C/025/0005

**Subject: Evaluation of Pipeline from Pit 10 to Sediment Pond 3, Pond 1 and facility waterline revisions, Alton Coal Development, LLC, Coal Hollow Mine, Kane County, Utah, C/025/0005, Task 4967**

**Title:** Pit 10 to Pond 3 Pipeline, Pond 1 and Facilities update Task ID 4967

**SEDIMENT IMPOUNDMENT POND 1 DETAILS**  
**COAL HOLLOW PROJECT**  
**ALTON, UTAH**  
**DRAWING: 5-28**

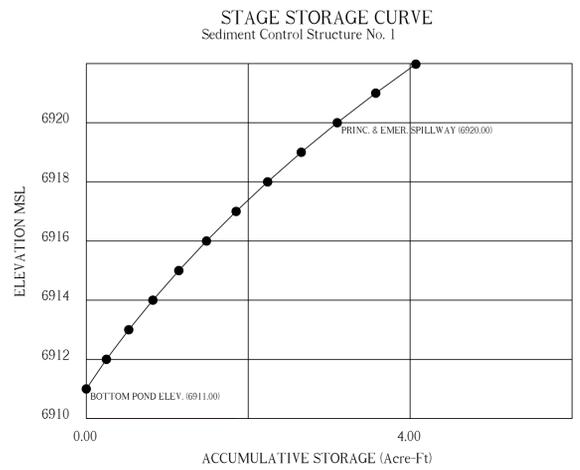
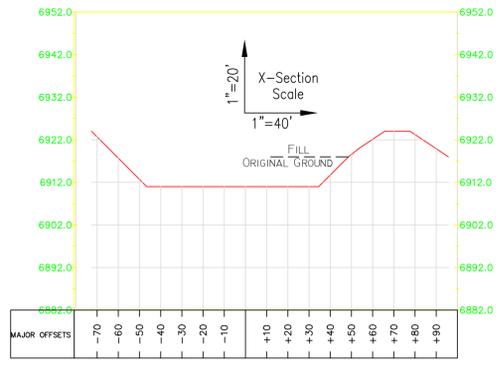
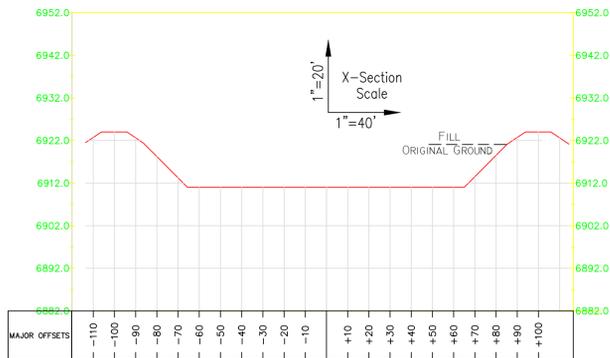
R645-742.221.33: The amendment does not meet the minimum hydrologic requirements for sediment pond sizing in the State Coal Mining rules. The amendment needs to provide a narrative of the methodology and show the calculations for determining 4.95 ac.ft. is the runoff volume for a 10-year 24-hour event from Watershed 3 (Dwg. 5-26). These calculations will be shown and added to the Sediment Impoundment Sizing tables in Appendix 5-2.

*The tables and text of Appendix 5-2 have been update to show the inputs for determining the 4.95 ac. ft. capacity needed for containing the 10-year 24-hour storm event.*

**DRAWING: 5-30**

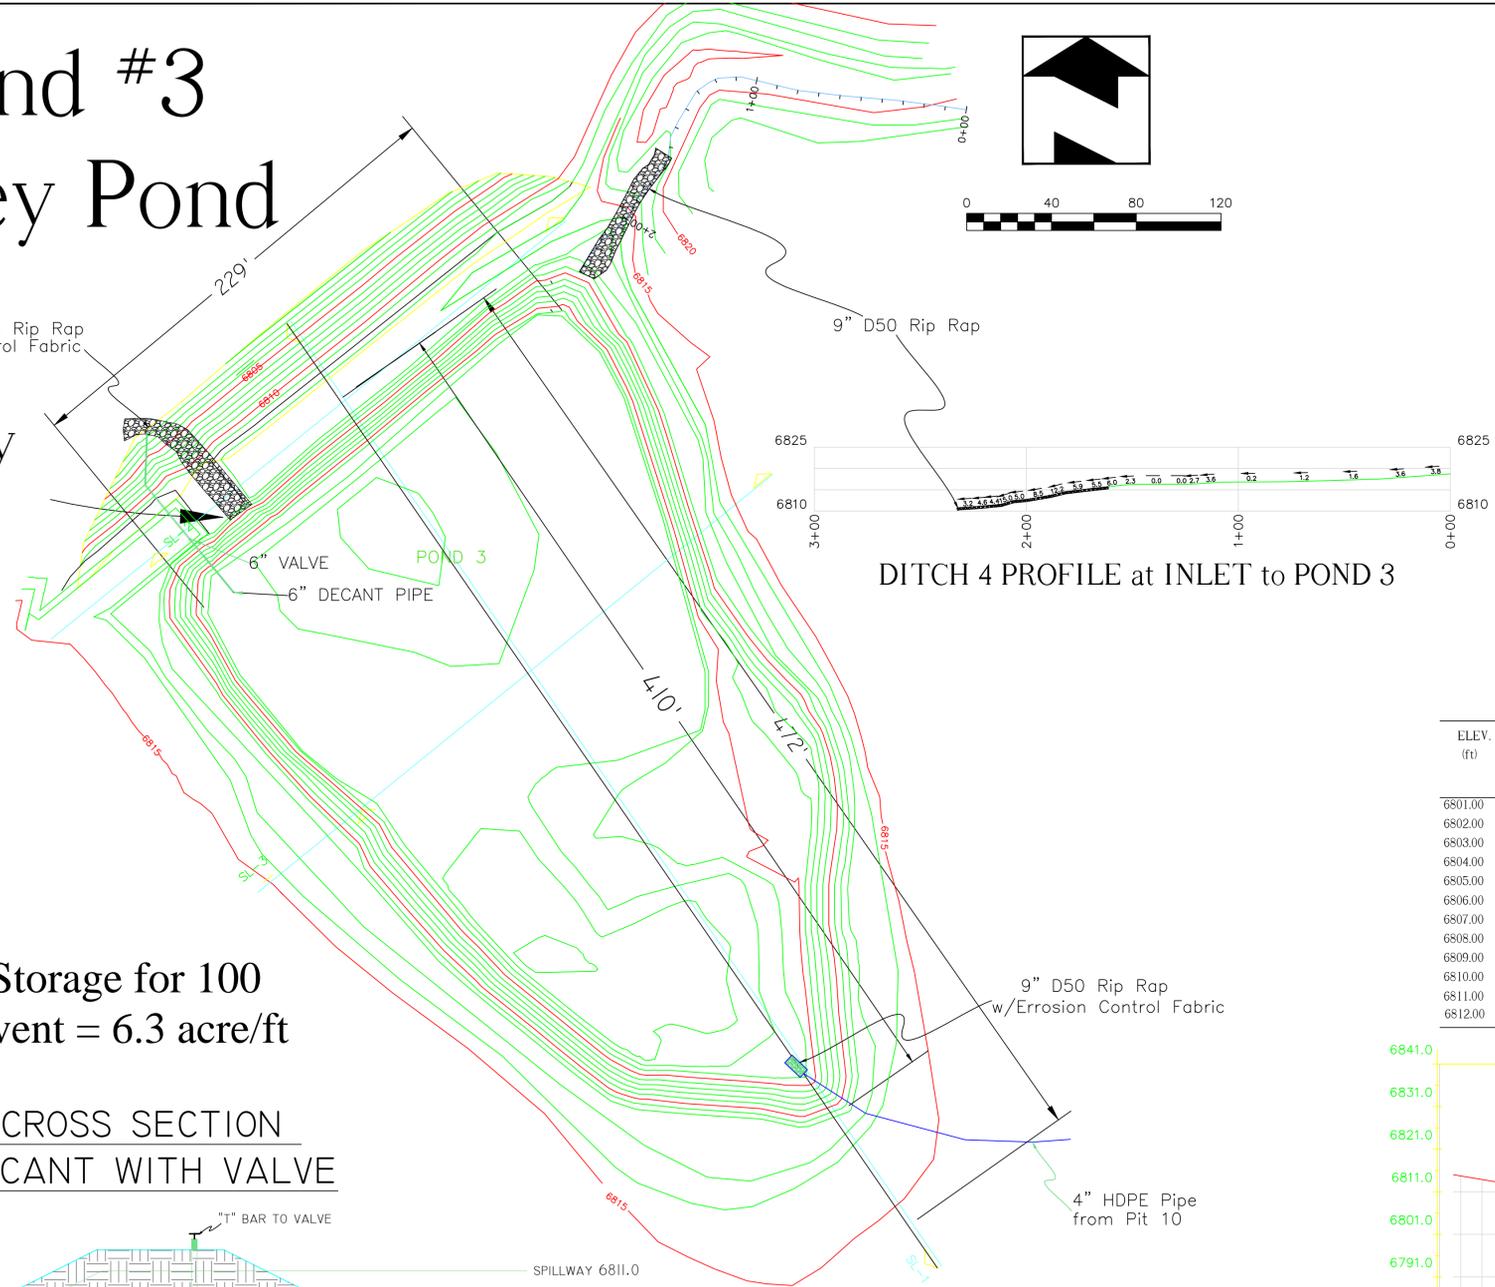
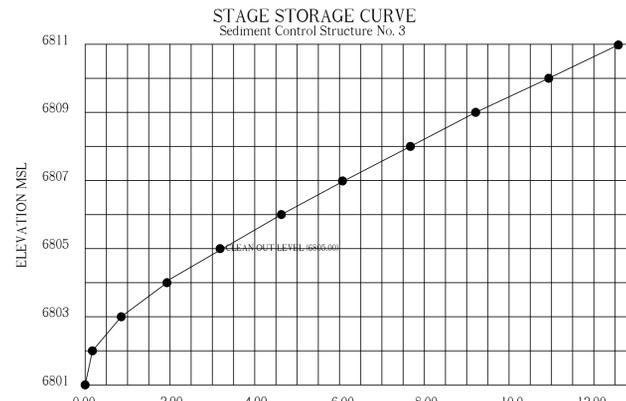
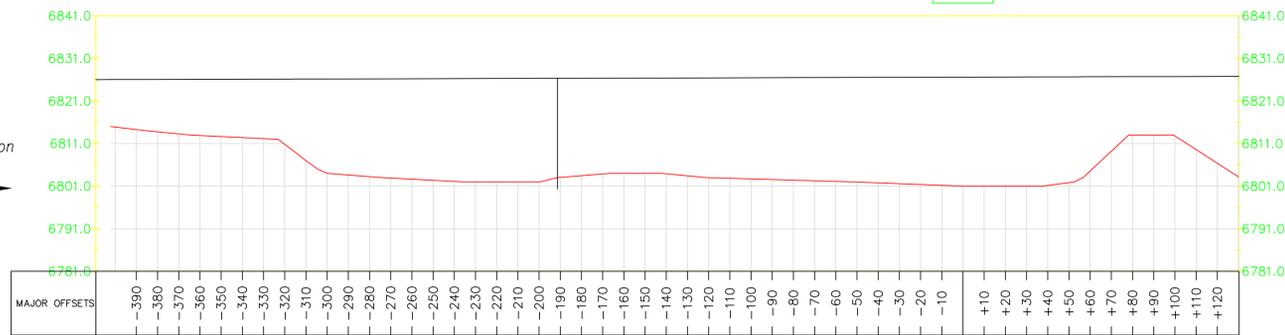
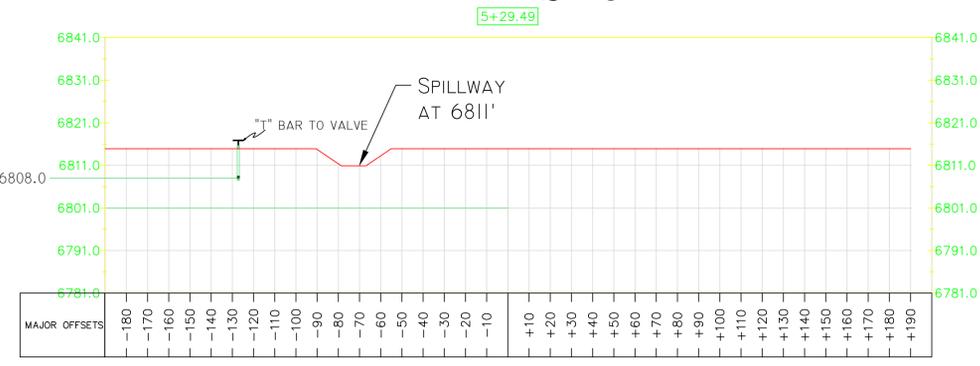
R645-301-742.123: The amendment does not meet the minimum hydrologic requirements of diverting runoff in a protected channel. Appendix 5-2 shows the calculated flow velocity of Ditch 4 exceeds the reasonable non-erosive velocity of 4-5 fps for a grass lined open channel. Runoff velocities in Ditch 4

increase even beyond the calculated velocity when routed through the inlet to Pond 3 because there is a steep drop in elevation into the pond. The application must design the inlet to Sediment Pond 3 so it is stable and provide calculation for rip-rap sizing. Drawing 5-30 will be updated to show the new design that will stabilize the inlet.

*Appendix 5-2 has been amended to include the calculation for rip-rap sizing. Also, Drawing 5-30 has been revised to show the rip-rap section of the inlet to Pond 3(a section of Ditch 4).*

It should be noted that ditch 4 steepens as it drops into Pond 3. The inlet area is protected from erosion by installation of 9” D50 rip-rap as shown on Drawing 5-30.
